UCC28632 is between VDD and GND waveform

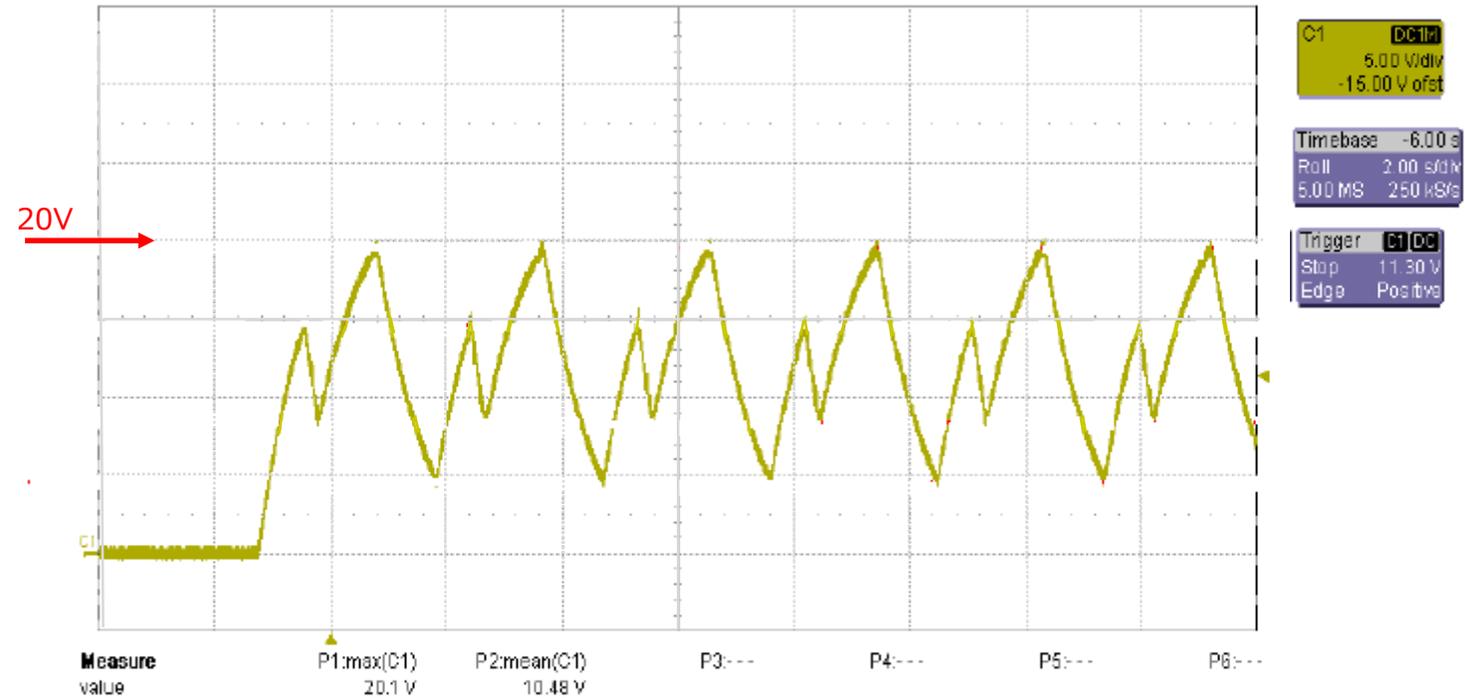
When the output on the secondary side is shorted,
Basically, I think that the rising voltage of VDD is repeated at VDD (start) level, but the VDD (start) level and rising to nearly 20 V are alternately repeated.

1. What kind of state (control) is this rise near 20 V?
2. Is this operation normal as the operation of the VDD pin when the secondary side output is shorted?
3. The maximum rating of the VDD voltage is 20V.
Is there a problem?
Is there a way to solve it?
